CITY OF WESTMINSTER
Special Mayor and Common Council Meeting
Wednesday, June 3, 2020 at 2 pm
<https://www.facebook.com/westminstermd/>

Re: Approval – Warner Construction Contract Change Order Nos. 5, 6, and 7

Re: City of Westminster Administrative Office Building Renovations & Alterations
Project no. 20-02

Name Westminster Administration Building
Address 45 W Main Street, Westminster, MD 21157
Date of Contract: 11/25/2019

SECOND FLOOR PLAN

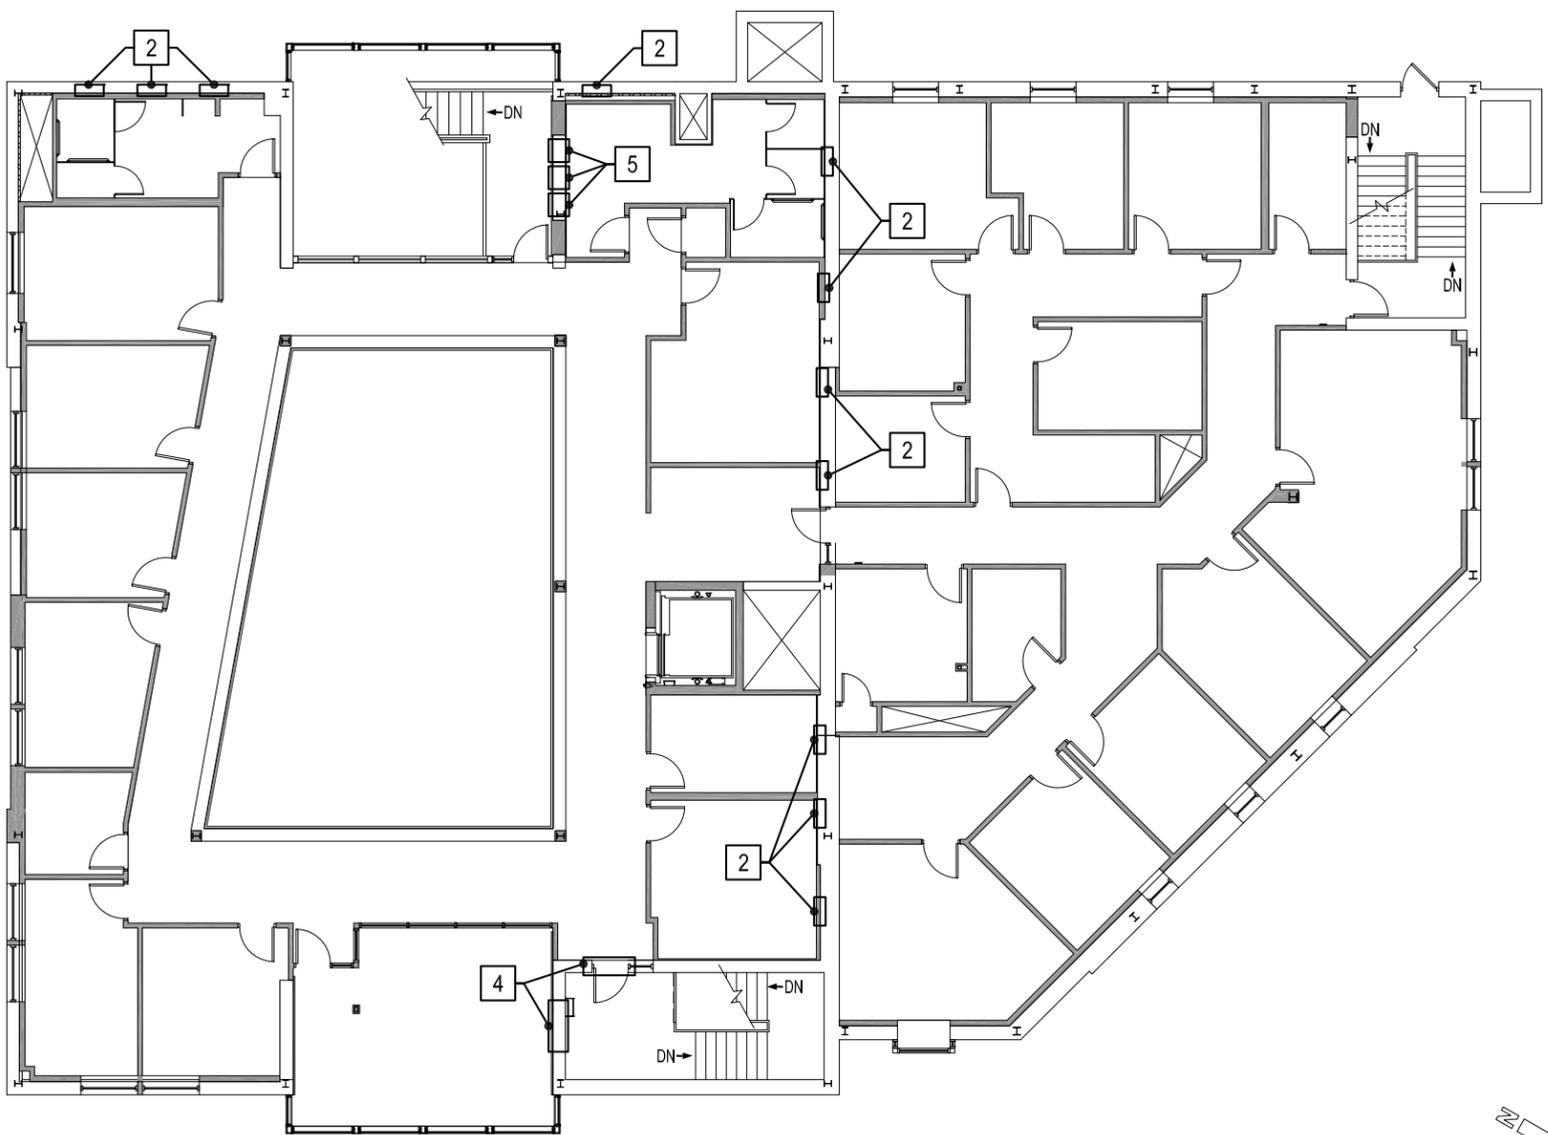
- 5 Abandoned HVAC Passages Through Stair 2: (3)
Infill abandoned HVAC duct passage through CMU block wall using masonry to match existing; tooth new masonry into existing. Install fire stopping as needed to seal deck penetration.
